International Code Council

**ICC 500-2020 edition
Public Input Agenda with
Committee Votes and Public Comments
based on input received
on 2014 edition of the
ICC 500 Standard**

**For February, 2020
2nd Meeting – Teleconference**

2014 ICC 500-Standard Revision Proposals – Public Comments

Figure 504.1.1

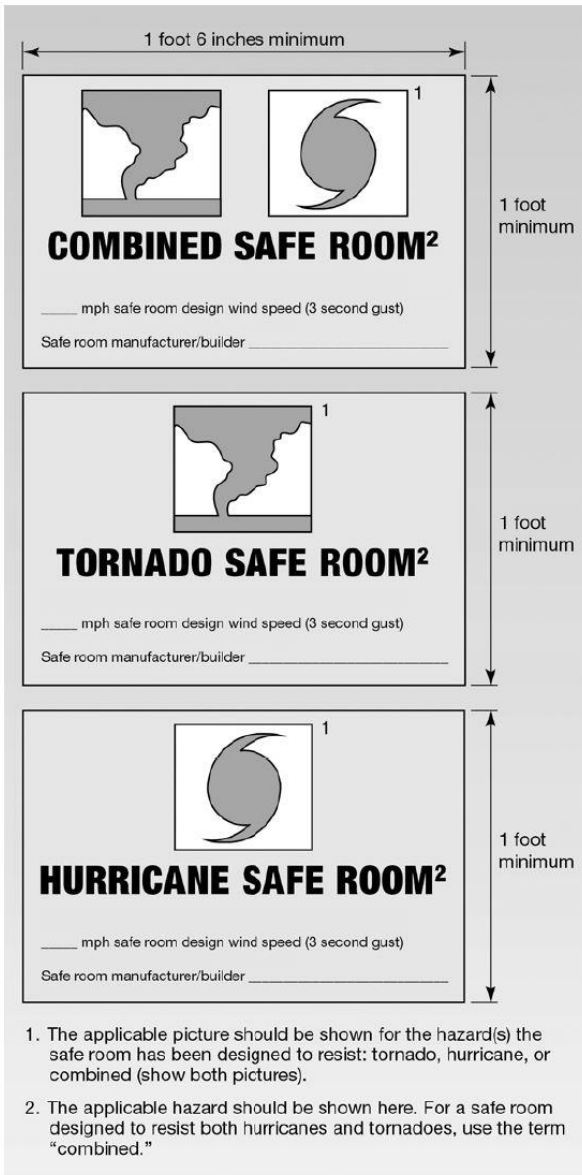
Staff Note: Modifications were also submitted for Commentary Figure 504.1.1 and 504.1.2

Add “Tornado Shelter Design Capacity: 1,500” to Figure 504.1.1.

Add “Tornado Shelter Design Capacity: 2,500” and “Hurricane Shelter Design Capacity: 1,500: to the top sign in Figure 504.1.2.

Add “Tornado Shelter Design Capacity: 400” to the middle sign in Figure 504.1.2.

Add “Hurricane Shelter Design Capacity: 2,000” to the bottom sign in Figure 504.1.2.

Committee Action: As modified (7-0 meeting) (12-0 electronic vote)

FIGURE ~~303.2~~ 303.1.1

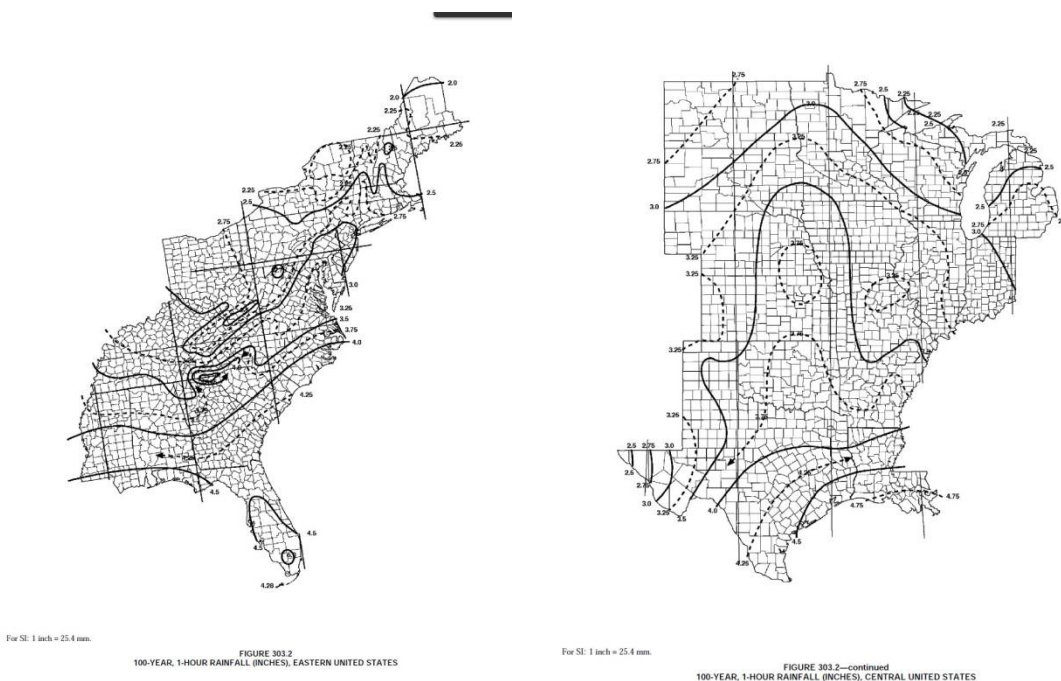
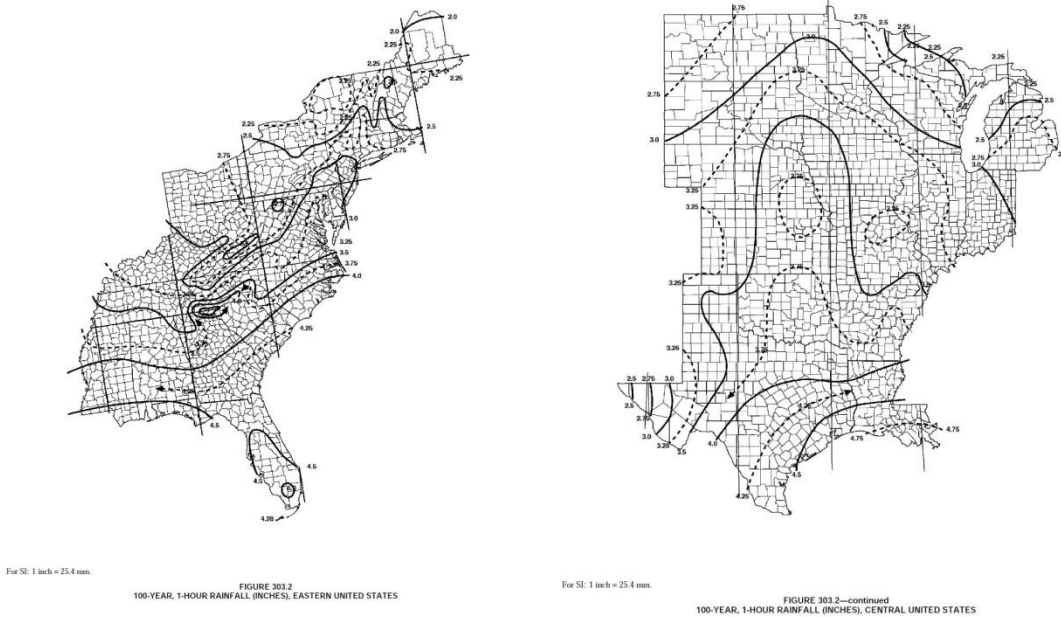
303.1.1. Rainfall rate. The rainfall rate shall be determined by adding 6 inches (152.4 mm) of rainfall per hour to the rainfall rate established from Figure ~~303.2~~ 303.1.1.

Reason: Figure 303.2 is referenced in Section 303.1.1 and not in Section 303.2. Section 303.2 has nothing to do with the figure.

See 2018 IBC Figure 1611.1 for 100-Year, 1- Hour Rainfall (Inches) for Western United States , Alaska and Hawaii.

303.1.1. Rainfall rate. The rainfall rate shall be determined by adding 6 inches (152.4 mm) of rainfall per hour to the 100-year, 1-hour rainfall rate established from Figure ~~303.2~~ 303.1.1. For locations not illustrated in the figure, determine the 100 year, 1-hour rainfall rate from approved local weather data.

Committee action: Approval as Further Modified		
	Affirmative	Affirmative with comment	Negative with comment	Abstain with reason
Schultz Vote:		x		
Your comment/reason: 303.1.1 Rainfall rate states “or from approved local weather data”. It is unclear who is the approver of this data?				
No revisions suggested.				
<p>303.1.1. Rainfall rate. The rainfall rate shall be determined by adding 6 inches (152.4 mm) of rainfall per hour to the 100-year, 1-hour rainfall rate. The 100-year, 1 hour rainfall rate shall be determined from Figure 303.1.1 or approved local weather data.</p>

Committee action: Approval as Further Modified		
	Affirmative	Affirmative with comment	Negative with comment	Abstain with reason
Scott Vote:		x		
Your comment/reason: Editorial – “Western” in Western United States map caption is spelled wrong (Westerm)				
Revise as follows:				
<p>FIGURE 303.1.1—continued 100-YEAR, 1-HOUR RAINFALL (INCHES), WESTERN WESTERN UNITED STATES</p>

Figure 304.2(2) SHELTER DESIGN WIND SPEEDS FOR HURRICANES

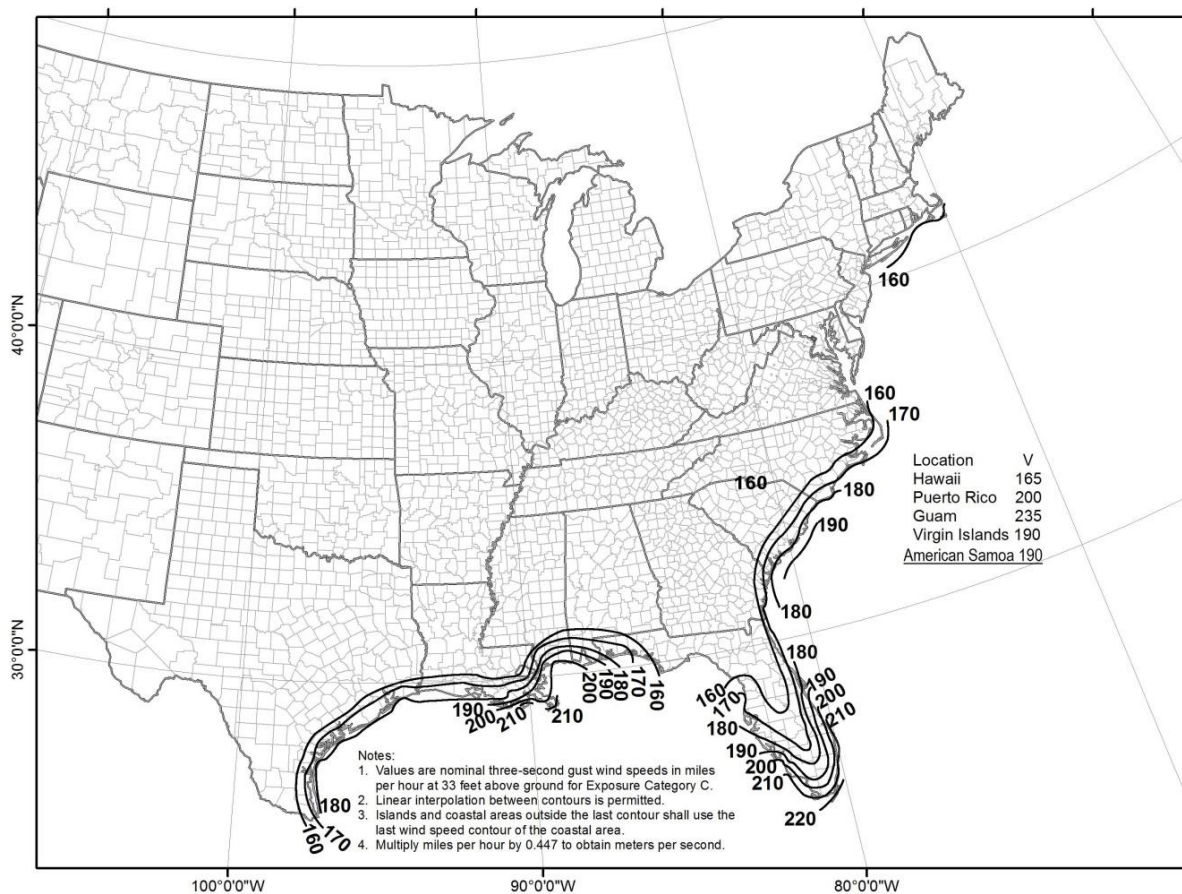
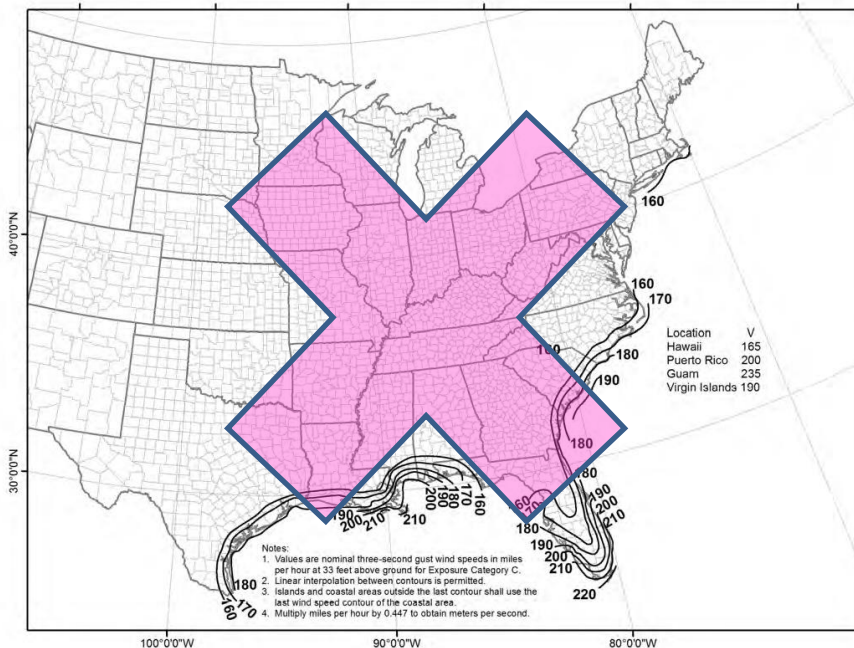
Reason: Currently Figure 304.2(2), the Shelter Design Wind Speeds for Hurricanes, does not specify a design wind speed for American Samoa where hurricanes are the greatest high wind hazard, and a 10,000 year MRI analysis is not currently available. From the ASCE 7 wind speed maps for 300, 700, 1700, and 3000 years, it turns out that the Virgin Islands and American Samoa wind speeds at each of these return periods are almost identical, meaning the hazard curves have a similar shape at the two locations. On the ASCE 7-16 Risk Category IV map,

American Samoa and the US Virgin Islands both have design wind speed of 180 mph. Therefore, the proposed wind speed for American Samoa is the same as the 10,000 year MRI wind speed that is currently used for the US Virgin Islands, 190 mph.

Committee Action: Approved as Modified (10-0)

Notes: Will also revise name for US Virgin Islands and add Commonwealth of the Northern Mariana Islands and American Samoa to full map. ARA will provide revised map for standard.

Rotate maps to landscape in final draft.

FIGURE 304.2(2)
STORM SHELTER DESIGN WIND SPEEDS, V , FOR HURRICANES

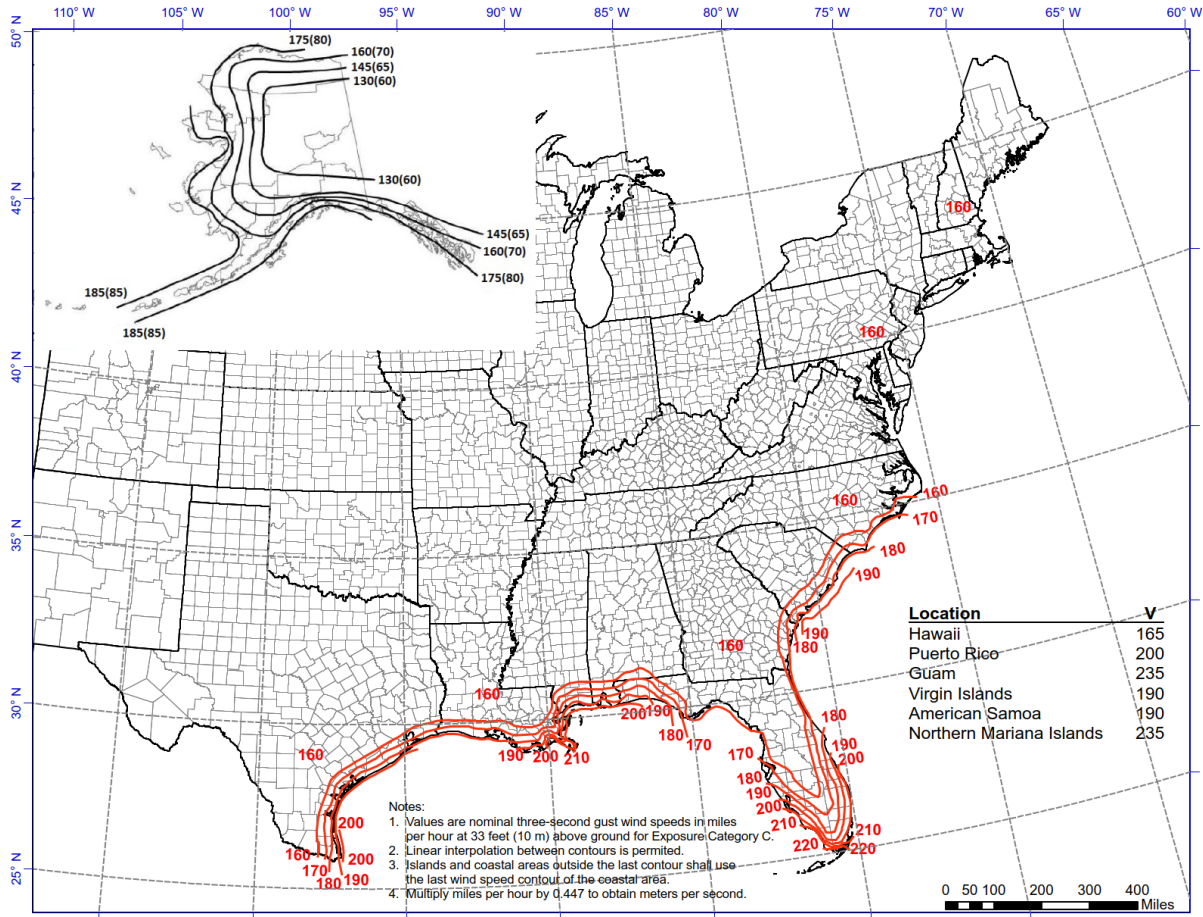
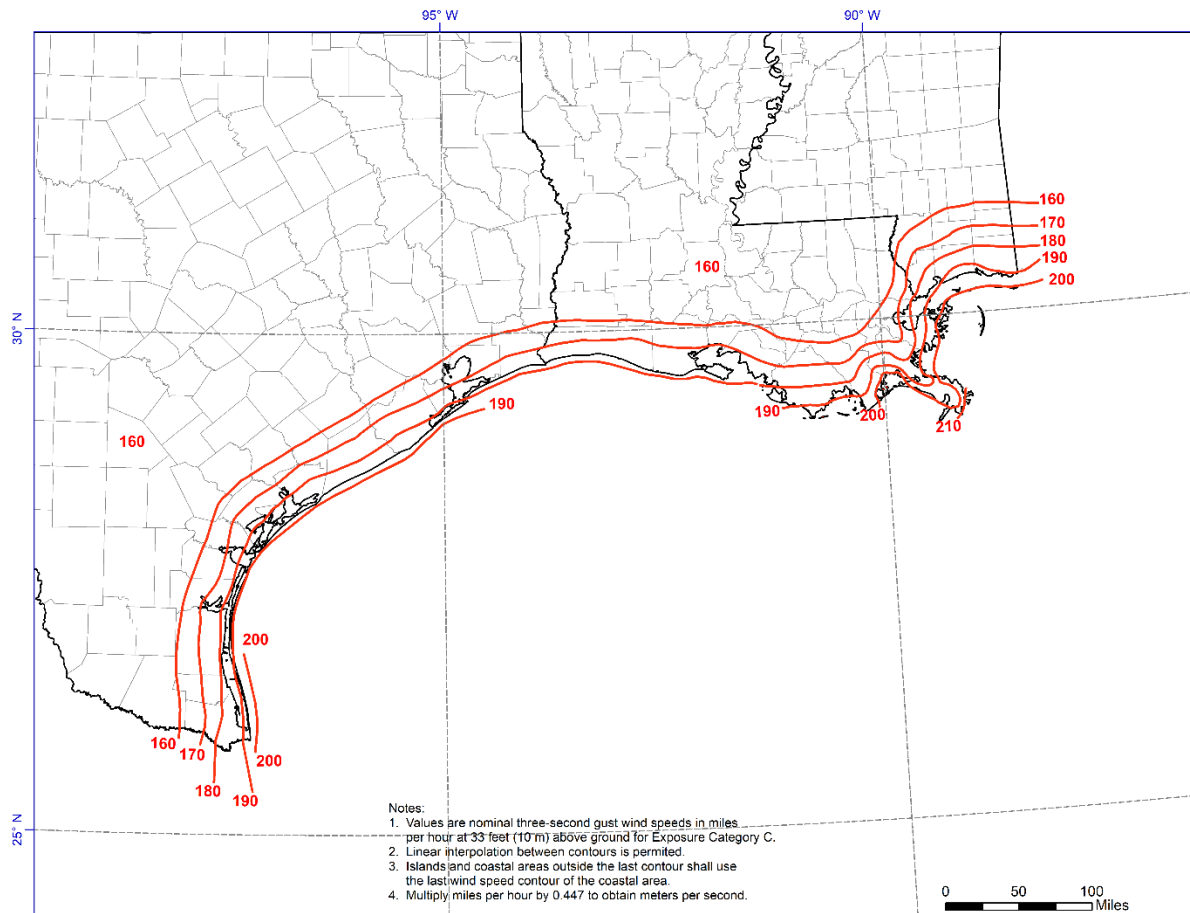
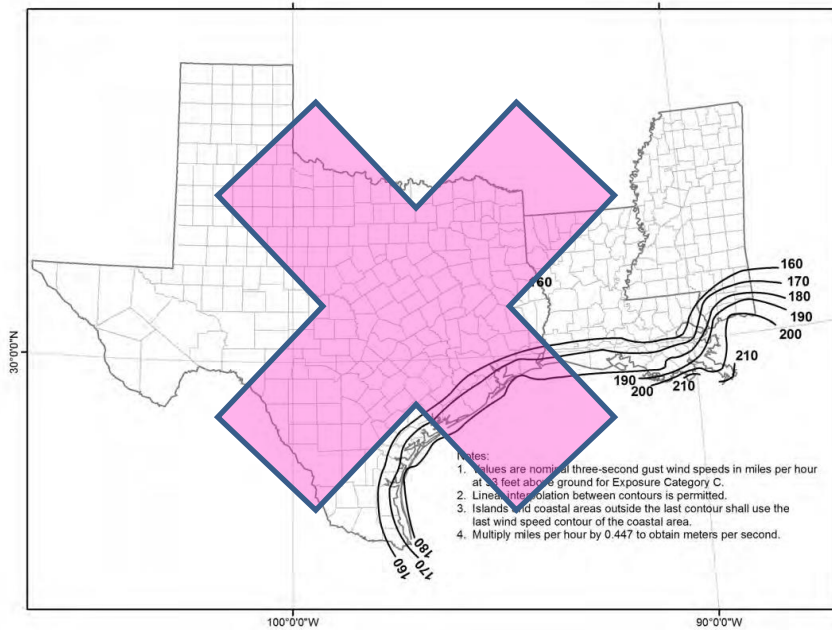
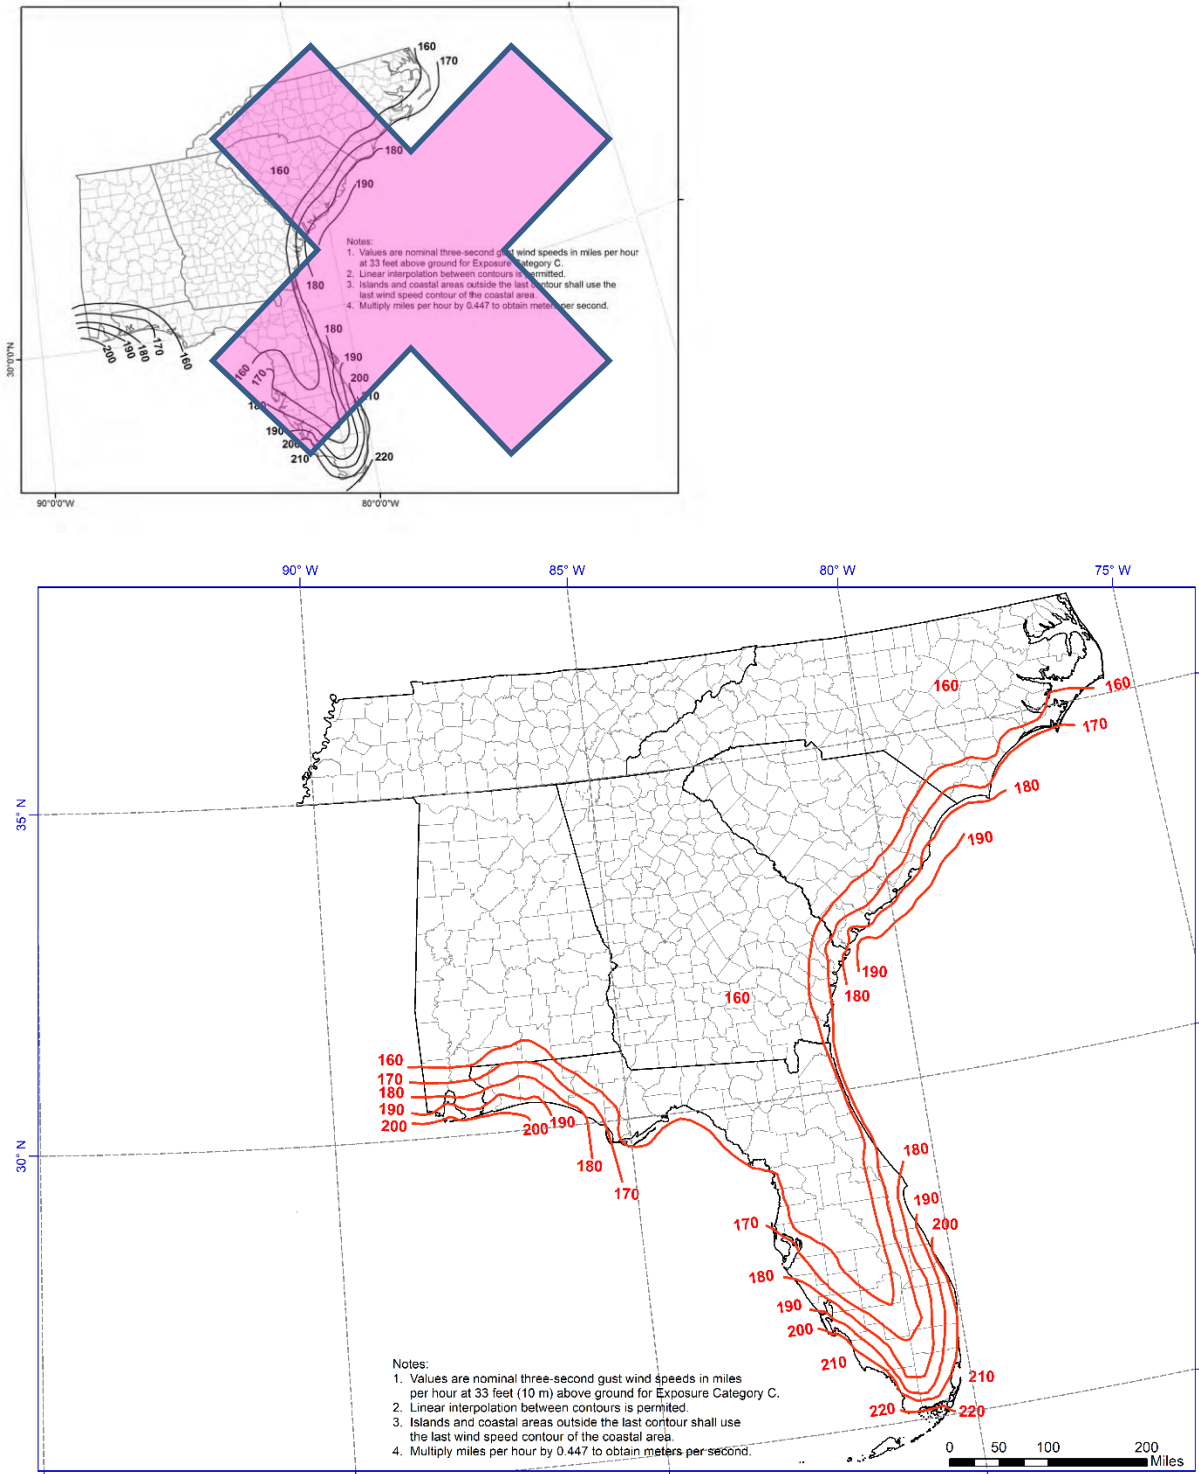
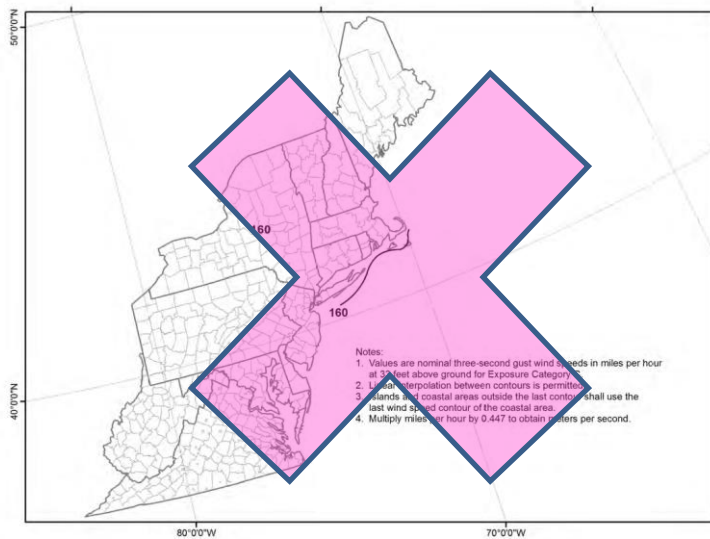
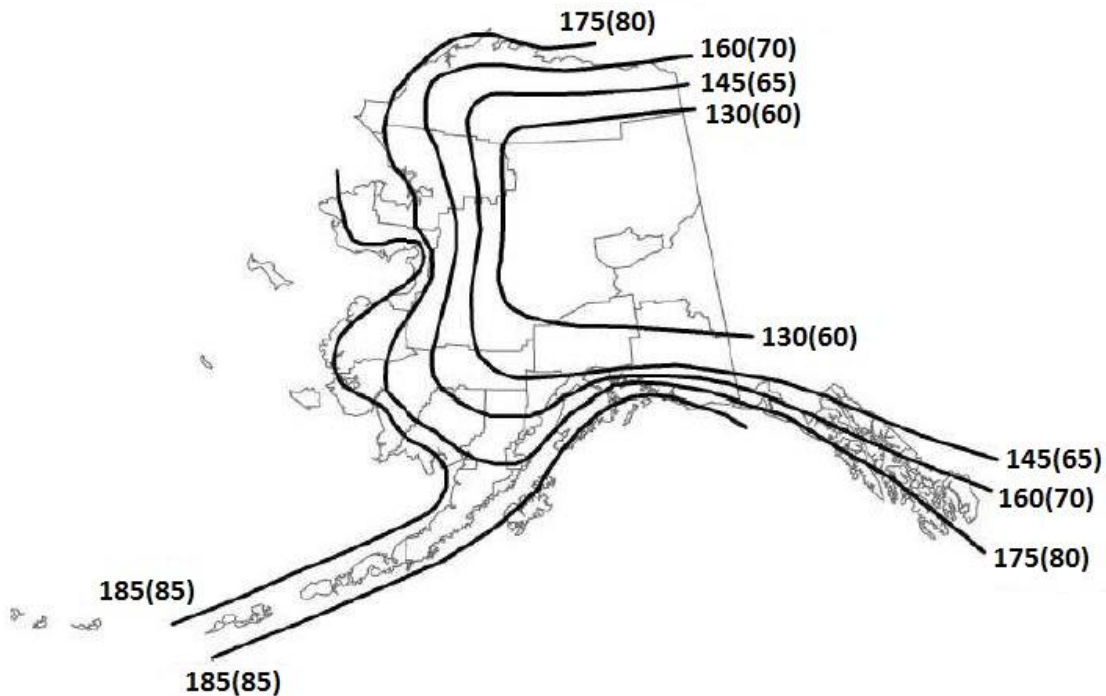
Delete four current maps and replace with the following

Committee Reason: Revised maps to coordinate with latest information for hurricane winds. Add Alaska because that state is affected by hurricane winds. Full list of islands is needed.
